Notice of Intent

Type of Submission: Notice of Intent	Type of Action: Recompletion
Date Sundry Submitted: 02/20/2024	Time Sundry Submitted: 05:44
Date proposed operation will begin: 04/01/2024

Procedure Description: Hilcorp Energy Company requests to REVISE the previously BLM approved NOI (1/16/2024) to amend the FC perforation top. The subject well will be recompleted in the Fruitland Coal and downhole trimmingle with the existing CH/DK. Please see the attached revised procedure, current and proposed wellbore diagram, plat and natural gas management plan. A closed loop system will be used. Hilcorp will contact the FFO Surface group within 90 days after the well has been recompleted, before any interim reclamation work, to conduct the onsite. A reclamation plan will be submitted after the onsite.

HILCORP ENERGY COMPANY
McClanahan 14E
FRUITLAND COAL RECOMPLETE SUNDRY
API 3004523913

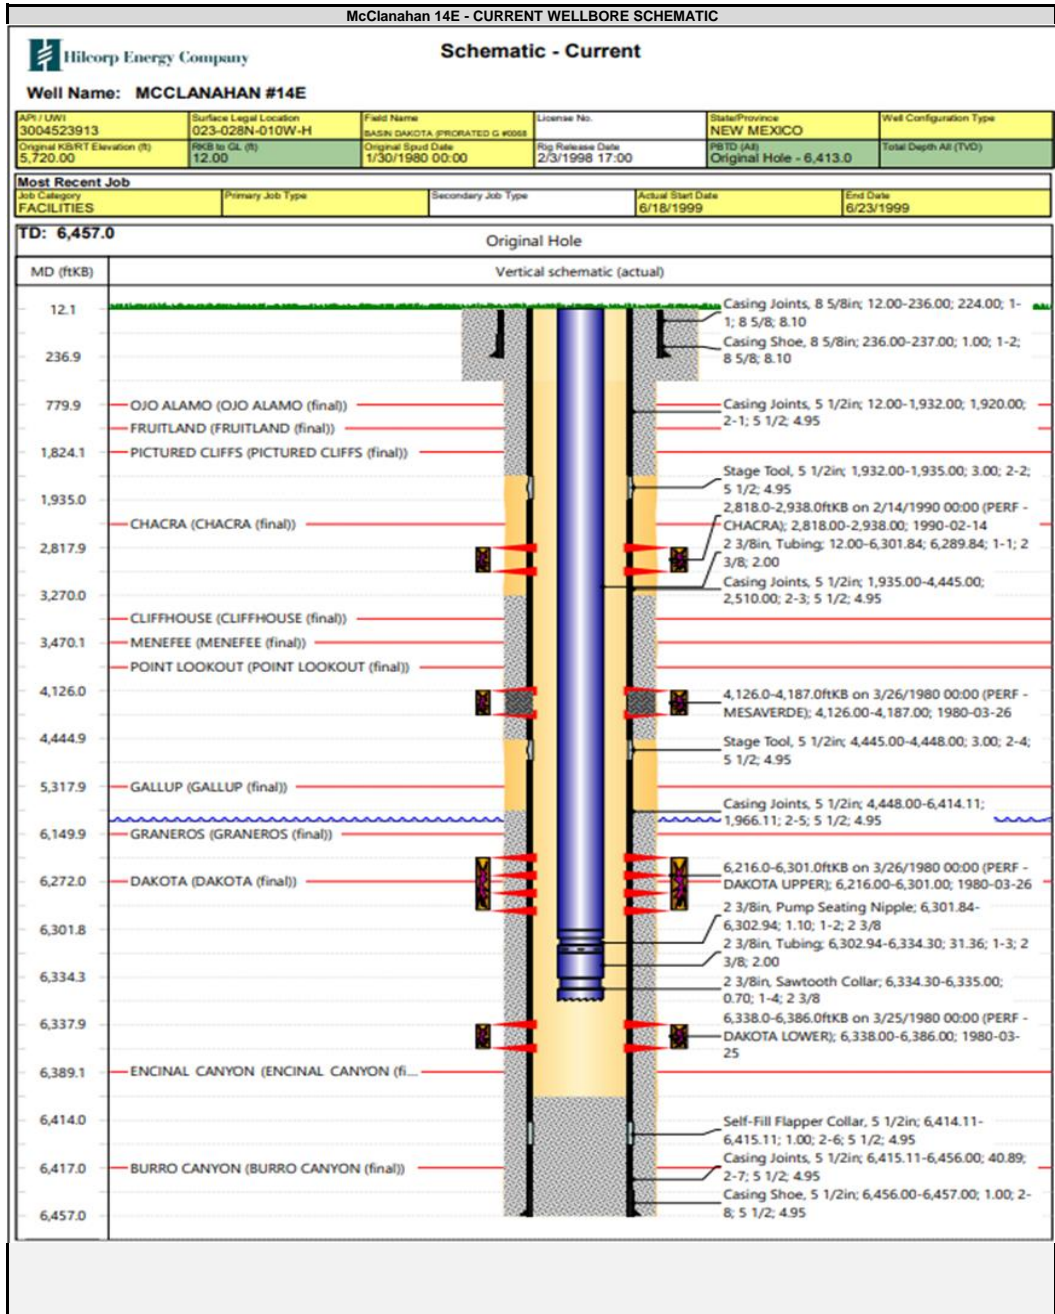
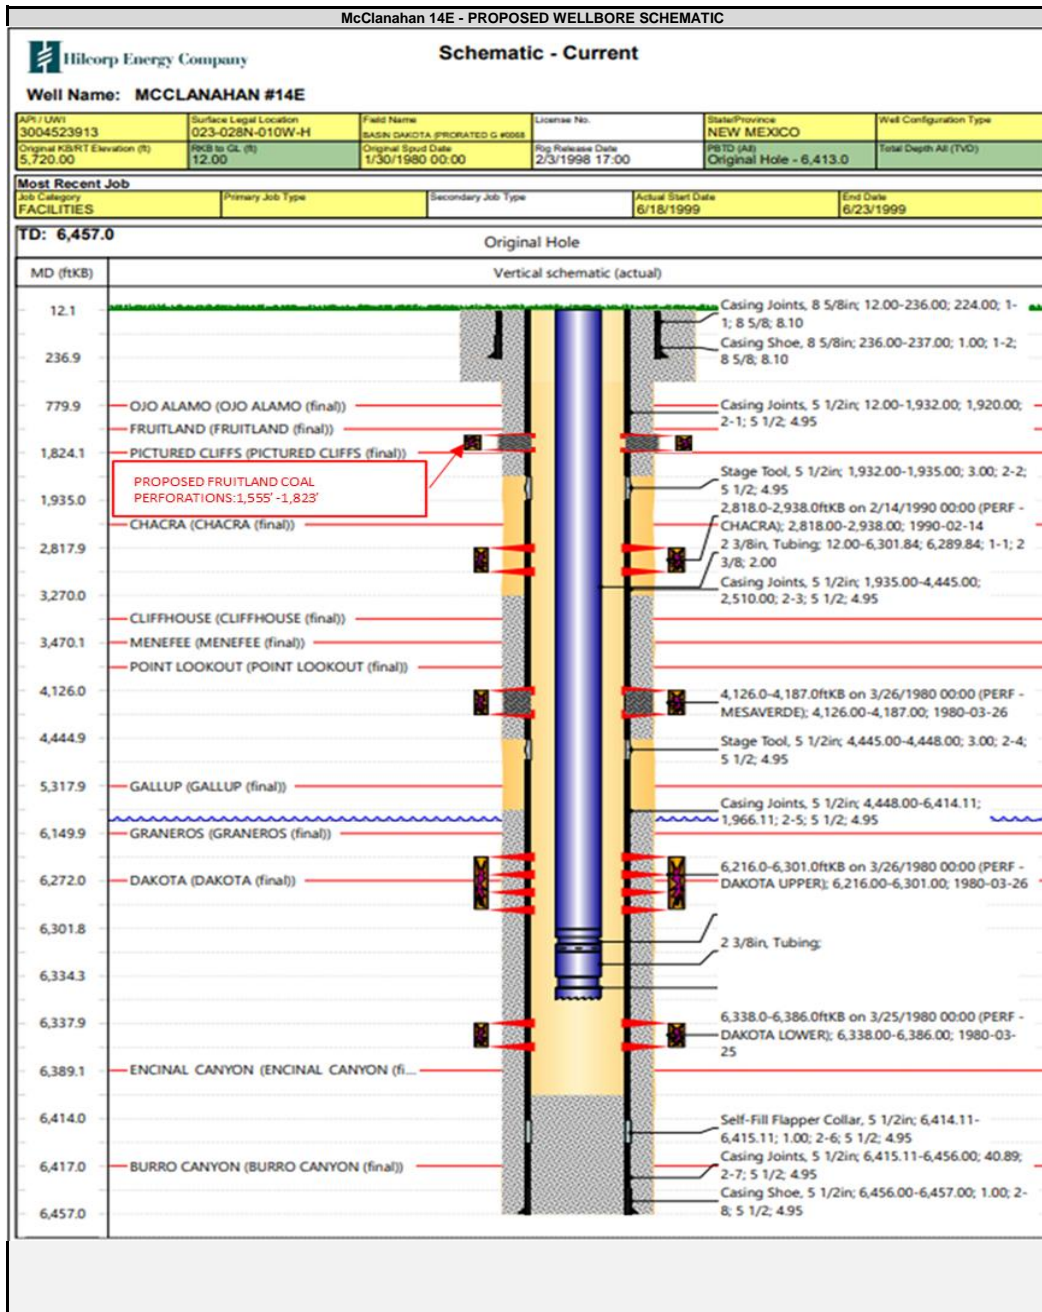
Additionally and maybe I am missing something on the WBD, but it seems to indicate that the MV perforations from 4126 to 4187 are still open. However, the well file seems to indicate that these perforations were squeezed in February of 1990. Please confirm that these perforations are squeezed.

I am confirming that the Mesaverde perforations were squeezed off in 2/1990 from 4126-4187'

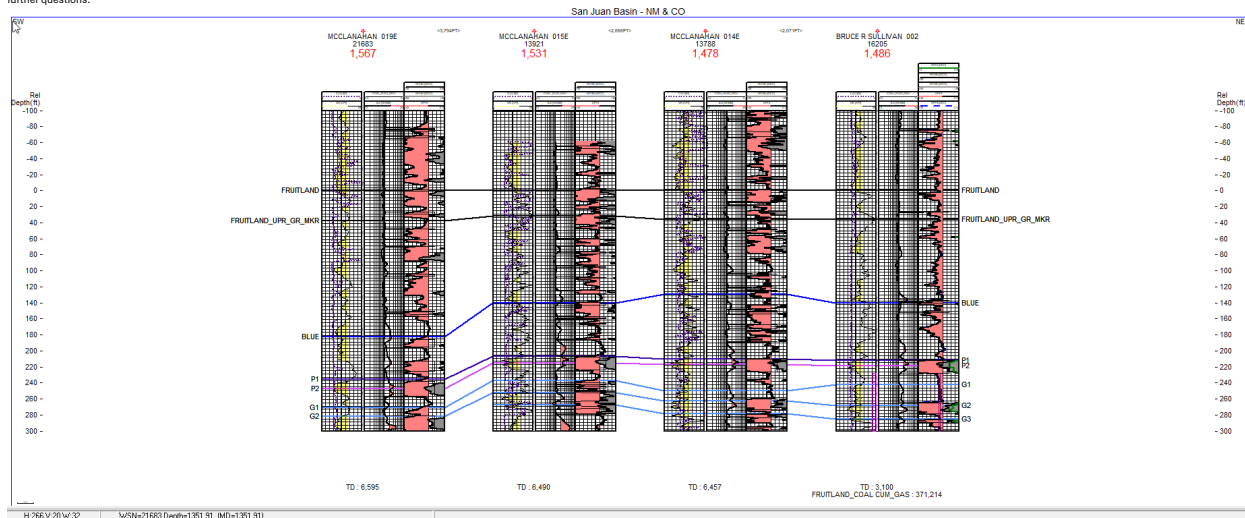
Please note that the vertical limits of the basin FLC pool do not include the entirety of the fruitland formation. Instead only the lower thicker coal seams are included, which is typically where Hilcorp has been targeting in the recent past. Does Hilcorp actually intend to perforate at the proposed shallower depth or was some "wriggle" room engineered into the proposal?

At your technical team's discretion, please review the attached order that stipulates the pool's vertical limits and the type logs it specifies. How were the tops in the provided cross section determined? I will note that the pool does not include all the coal seams and as far as I can tell it is difficult to make a determination based off density logs as the pool boundary does not seem to be at an easily identifiable density transition.

- An amended sundry with the proposed top perforation adjusted from 1478' to 1555' be submitted to the Division.
- Hilcorp shall not perforate above a depth of 1555'.
- Notify NMOC 24 Hours Prior to beginning operations
- DHC required
- All conducted logs shall be submitted to the Division.
- The appropriate compliance officer supervisor shall be consulted and remedial action conducted as directed if the cement sheath around the casing is not adequate to protect the casing and isolate strata from: (a) the uppermost perforation in each added pool to at least 150 feet above that perforation; and (b) the lowermost perforation in each added pool to at least 100 feet below that perforation.

Please see the comments below for both questions. It looks like we didn't zoom in to show the squeeze on the schematic, but it is there as noted below.

I have checked the McClanahan 14E Fruitland top against the offset wells and they are consistent. The depth is 1478' MD. The cross-section below shows the subject well is position 3 from the left. Fruitland tops are posted in red in the Header. Let me know if you have further questions.

We see a bulk density reading that is less than 1.95 g/cc above the NMOC top indicating a coal seam. Glory, please add any thoughts you might have on this.
